SUBMITTER No.	<b>417</b>	ISSUE REFERENCE:	<b>5000</b>
SUBMITTER TYPE	Council	TOR CATEGORY	<b>Nature Conservation</b>
NAME	<b>Isaac Regional Council</b>	RELEVANT EIS SECTION

### DETAILS OF THE ISSUE

Figure 1. Prediction curve for maximum incremental subsidence with the estimated linear relationship, MSEC Trend, adopted for Galilee Basin

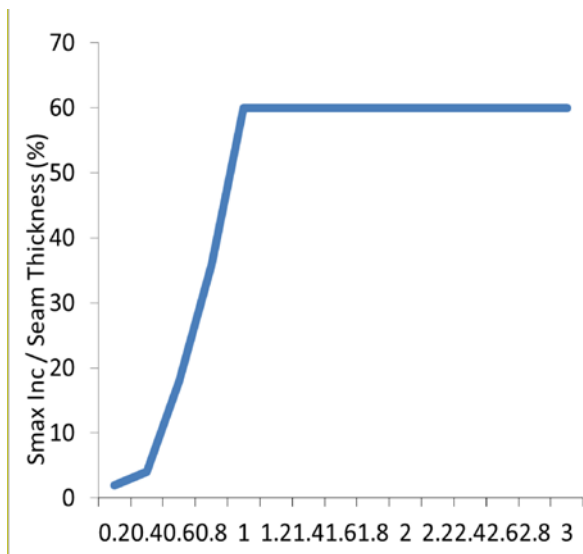
The EIS should provide sufficient detailed information on the predicted impacts of subsidence, including changes to topography, associated changes to drainage patterns including the location of predicted ponding within subsided panels and provide the mitigation measures required to minimise impacts including measures to reduce the impact on the landscape and the capture (take) of water resources. The proponent should refer to the DERM draft guideline (version 7.0) ‘Watercourse Subsidence – Central Queensland Mining Industry’ for further information.

The subsidence profiles used for the 3D extrapolation were based on subsidence parameters of angle of draw, maximum subsidence and pillar subsidence. Subsidence ranges from supercritical to subcritical below a depth of 481m. A caving angle of 26.5° has been used in this report.

Total subsidence comprises sag subsidence between pillars and the abutment subsidence above the pillars. The maximum sag subsidence is determined using the maximum subsidence/seam thickness and panel width to depth ratio profile as outlined in Figure 1, and is based on the prediction curves in MSEC (2007)<sup>3</sup>. The maximum sag subsidence for supercritical subsidence has a ratio of 0.6 times the seam thickness. For subcritical subsidence, the maximum sag subsidence is reduced as per the trend in Figure 1. Tables 1 and 2 give the summary of the calculations.
